Project	<b>IEEE 802.16 Broadband Wireless Access Working Group</b> < <a href="http://ieee802.org/16">http://ieee802.org/16</a> >	
Title	<b>Changes to the Section 15.1.4.1.2 Coexistence Messaging Interval</b>	
Date Submitted	<b>2007-01-08</b>	
Source(s)	John Sydor Communications Research Centre 3701 Carling Avenue Ottawa, Ontario	Voice: 613-998-2388 Fax: [Fax Number] <a href="mailto:john.sydor@crc.ca">john.sydor@crc.ca</a>
Re:	Changes to Draft Standard	
Abstract	Editorial changes to provide clarity and change; changes as suggested by comments in LB#24	
Purpose	Add consistency and clarity to draft document.	
Notice	This document has been prepared to assist IEEE 802.16. It is offered as a basis for discussion and is not binding on the contributing individual(s) or organization(s). The material in this document is subject to change in form and content after further study. The contributor(s) reserve(s) the right to add, amend or withdraw material contained herein.

## Changes to the Section 15.1.4.1.2 Coexistence Messaging Interval

The current draft document [1] has an outdated description of the Coexistence Messaging Interval, which is now embedded within the CXCC. The following edito

Figure h17 Example of claimed and unclaimed CMI (for a 5 Ms Frame Duration CXCC)

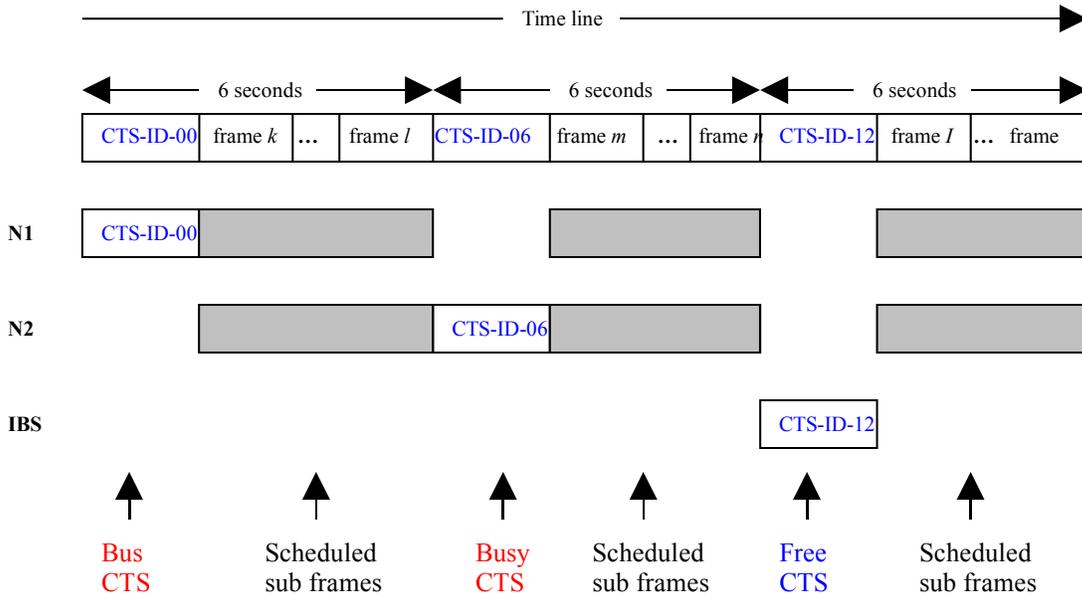
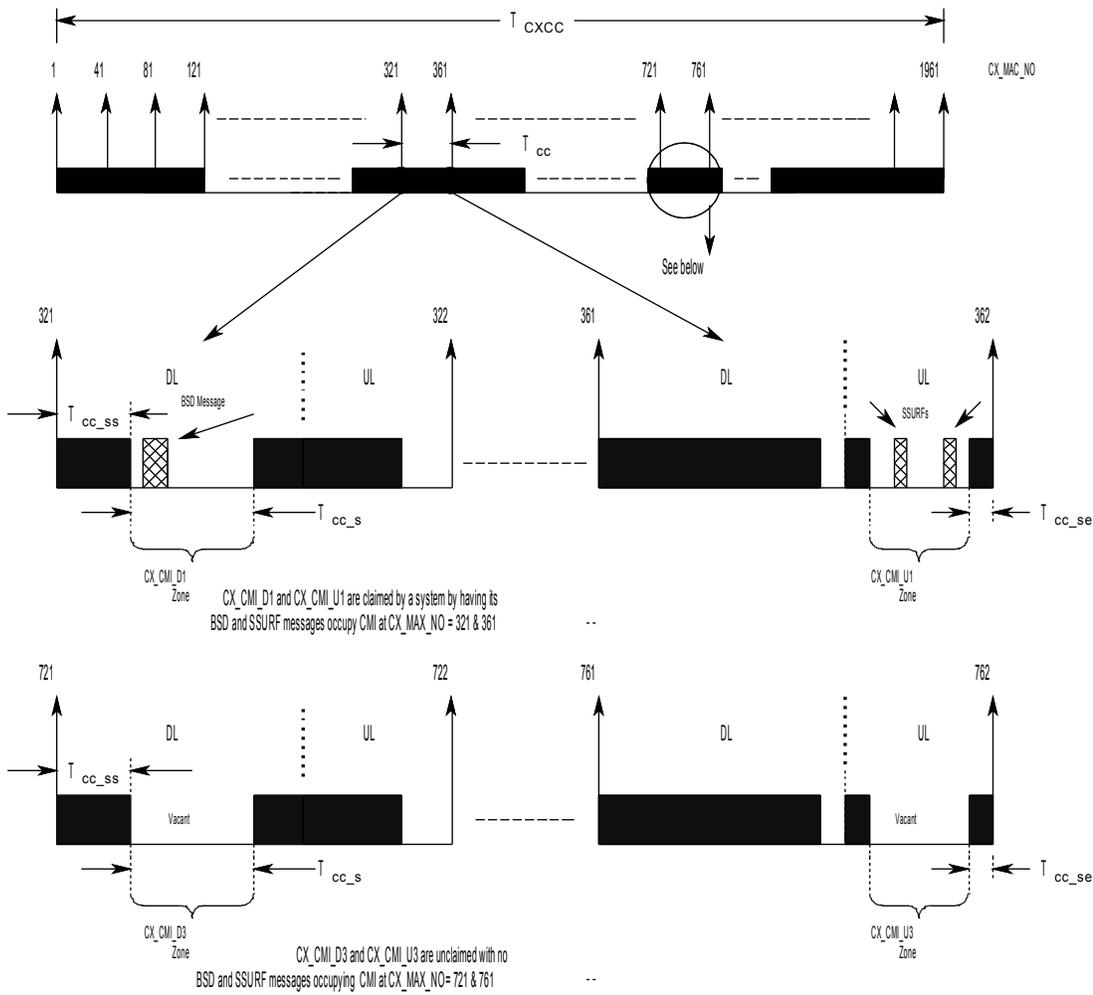
**Delete the current Figure h17 located on page 50 of [1] between lines 1 and 24, as shown below..**

*Replace the deleted Figure h17 above with the following new figure, and locate this new figure starting at Line 1 of Page 50 in the current [1].*

A Coexistence Community can consist of a maximum of ~~9~~ n=3 (and up to n=6 in future) systems (**TBD**). Each system claims a unique CMI by a process outlined in Section 15.3.2.3 Within the CXCC there are a total of 6 CMI available which repeat twice every CXCC cycle (Texcc) minute (TBD), but since CMI\_ID 54 is reserved for noise measurement and foreign system identification purposes, there are only 9 CMI available to the Coexistence Community. For example, a system claiming the CX\_CMI\_D1 would have two downlink transmission opportunities labeled (CX\_CMI\_D1) and two uplink transmission opportunities (CX\_CMI\_U1) in the Texcc cycle. A system must broadcast its BSD and SSURF messages ~~once~~ respectively on all of its claimed downlink and uplink CMI a minute on its CMI; when it does this all other members of the Coexistence Community remain silent and monitor to detect the extent of the interference that is caused by these specific transmissions this. This operation is a mechanism used by the Wireless MAN-CX same-PHY systems to sense each other's presence, and allows Cognitive Radio methods to be used to control and mitigate interference amongst Coexistence Community systems. The sparse packing of the CMI with randomly placed BSD and SSURF messages allows the detection of interference sources that may exist outside the Coexistence Community, as detailed in Section 15.3.2.1. Figure h17 shows an example of a claimed CMI slot pair within the CXCC and shows the relation to the uplink and downlink frame structure. Also shown is an unclaimed CMI pair. The figure shows the events at a given CX\_MAC\_NO, for a 5 ms frame duration.
